PARTS & SERVICE NEWS

REF NO.	AA02219
DATE	Oct. 8, 2002

SUBJECT: TIME RELAY FOR THE ENGINE PRELUB SYSTEM

PURPOSE: Introduction of an improved time relay

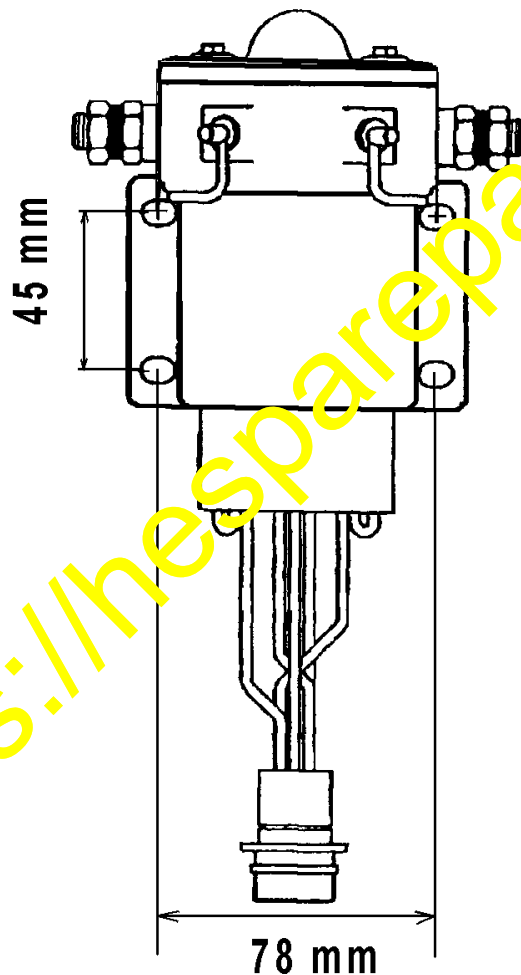
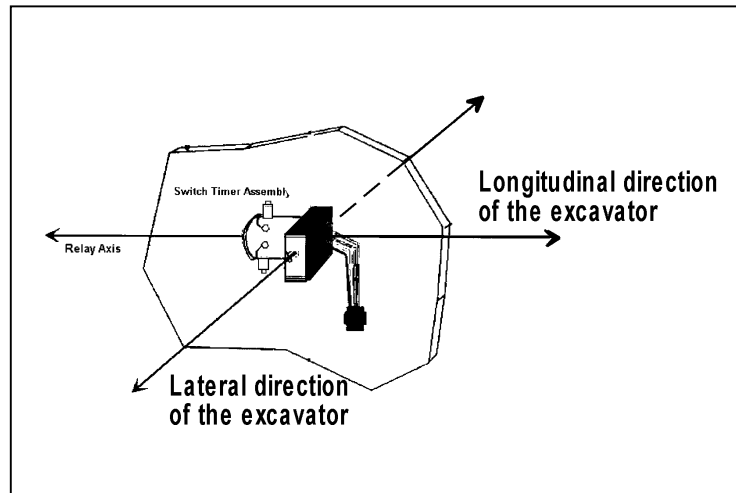
Present time relay: P/N 765 579 73

Improved time relay: P/N 792 585 73

- Disconnect and remove the old time relay.
- Mark out the 4 new holes (ø 8mm) and drill it.

The mounting technique of the relay should protect the unit from shock, vibration, excessive temperatures and direct high pressure sprays.

- Install the new relay elastically by means of the circular bearings (silent blocks) and the nuts.
- Widen up the 6 mm dia hole at the cable lag to approx. 8 mm with a drift mandrel **DO NOT DRILL.**
- Connect the new relay with the existing cable.
